SUBJECT: CHANGES TO PRESSURE-TEMPERATURE LIMITS IN TECHNICAL SPECIFICATIONS,  
SALEM NUCLEAR GENERATING STATION, UNIT 2 (TAC NO. M85693)

Amendment No. 129  
License No. DPR-75

SAFETY EVALUATION BY THE OFFICE OF NUCLEAR REACTOR REGULATION  
RELATED TO AMENDMENT NO. 129 TO FACILITY OPERATING LICENSE NO. DPR-75

SALEM NUCLEAR GENERATING STATION, UNIT NO. 2

Figure 3.4-2

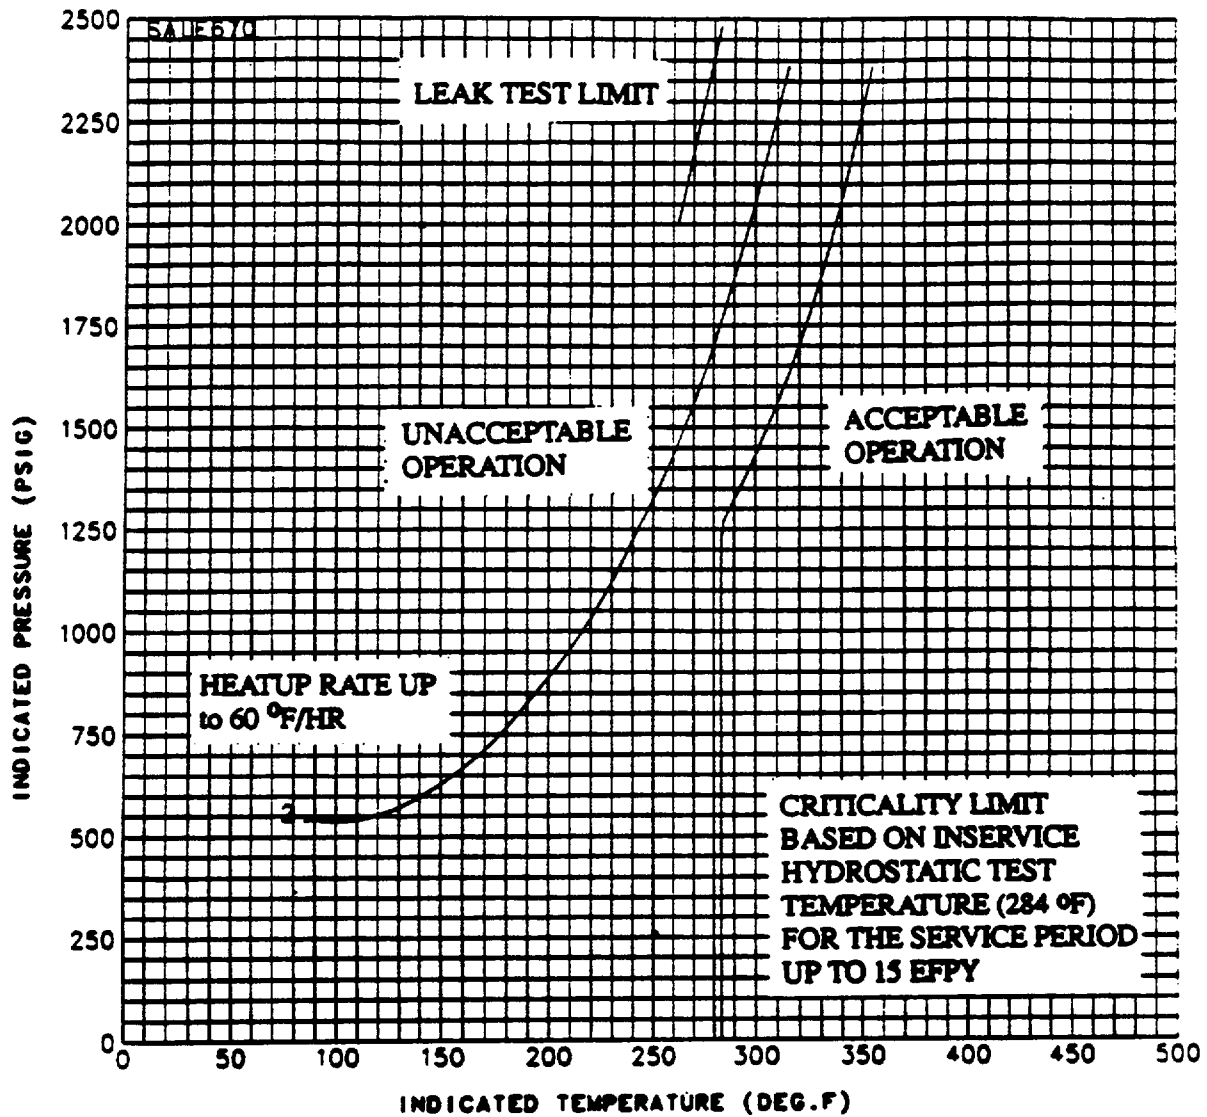
LIMITING ART AFTER 15 EFPY: 1/4T, 151°F  
3/4T, 102°F

SALEM UNIT 2 REACTOR COOLANT SYSTEM HEATUP LIMITATIONS APPLICABLE FOR THE FIRST 15 EFPY WITH MAXIMUM HEATUP RATE OF 60 F/HR. CURVE CONTAINS NO MARGIN FOR INSTRUMENT ERRORS.

By letter dated May 21, 1993, the State of New Jersey commented that on the revised heatup curve, Page 3/4 4-28, the area of acceptable operation is incorrectly shown to be above the criticality limit. By letter dated July 29, 1993, the licensee responded to the State of New Jersey's comment. The graph in question contains three limitation curves, a leak test limit, a heatup limit and a criticality limit. These curves are independent of each other. For all three curves, the area of acceptable operation is defined as below and to the right of the curves. Unacceptable operation is defined as above and to the left of the curves. The location of the "ACCEPTABLE OPERATION" label on the graph is below and to the right of all three curves. The staff finds the labeling of the graph acceptable.

Figure 3.4-3

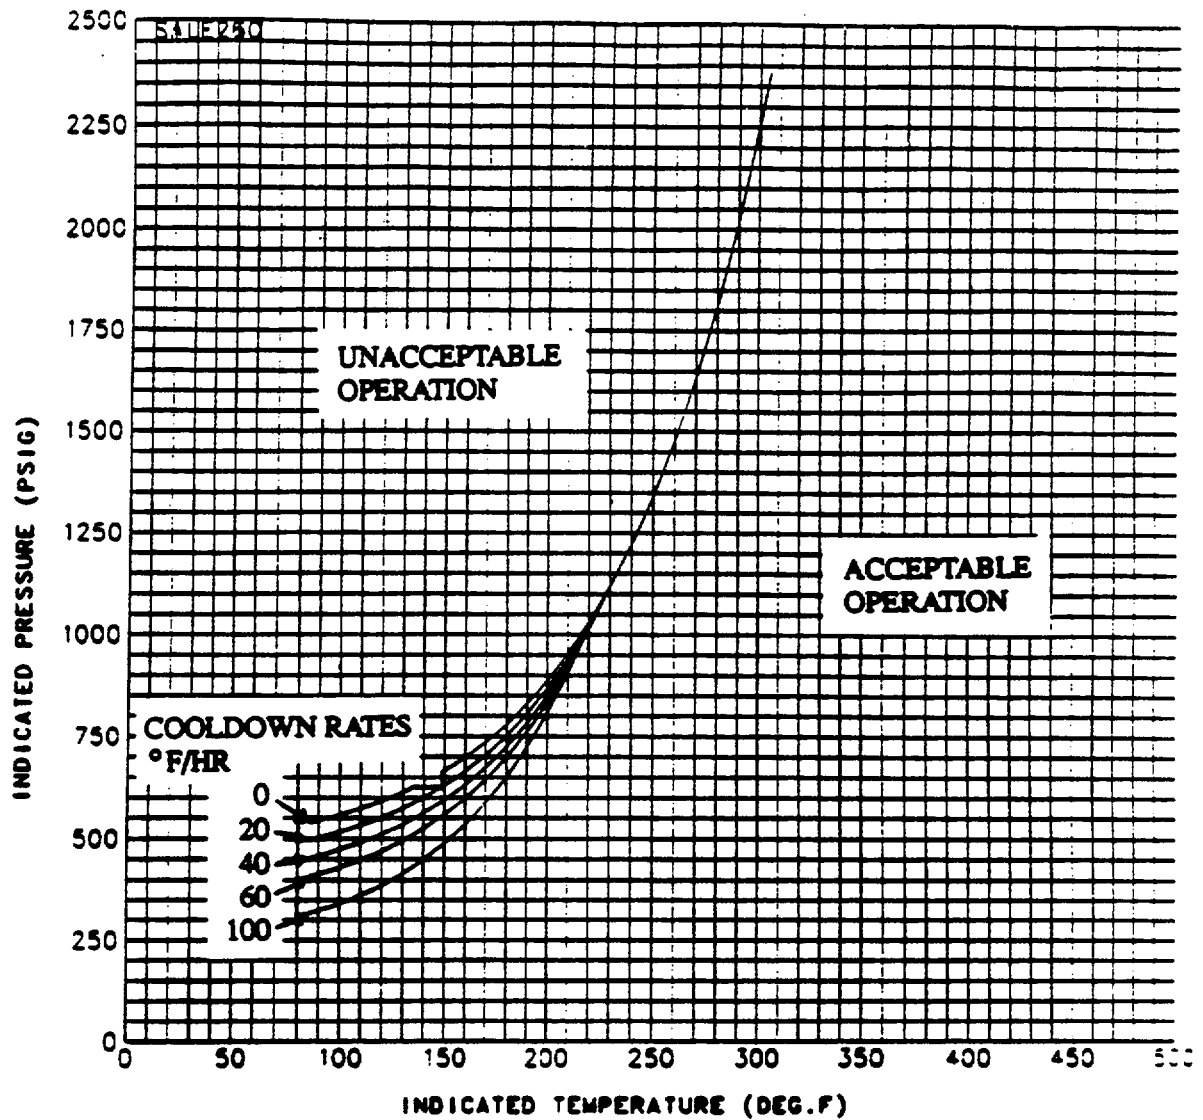
LIMITING ART AFTER 15 EFPY: 1/4T, 151°F  
3/4T, 102°F

SALEM UNIT 2 REACTOR COOLANT SYSTEM COOLDOWN LIMITATIONS APPLICABLE FOR THE FIRST 15 EFPY WITH MAXIMUM COOLDOWN RATE OF 100 F/HR. CURVE CONTAINS NO MARGIN FOR INSTRUMENT ERRORS.
